PCN: V06-019-E47540-MA

Product Change Notice

1000BASE-T SFP, see Appendix 1 for part numbers.

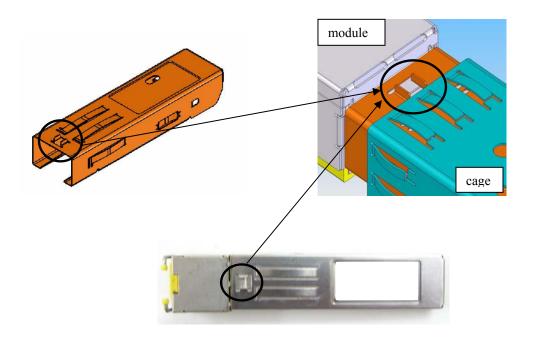
1) Add a hard stop feature to the top of 1000Base-T SFP housing

2) Extend the bottom housing emboss by 1.14mm to create a corner for better label protection.

- 1) To prevent module from over-travel when inserted into cage
- 2) Better label protection
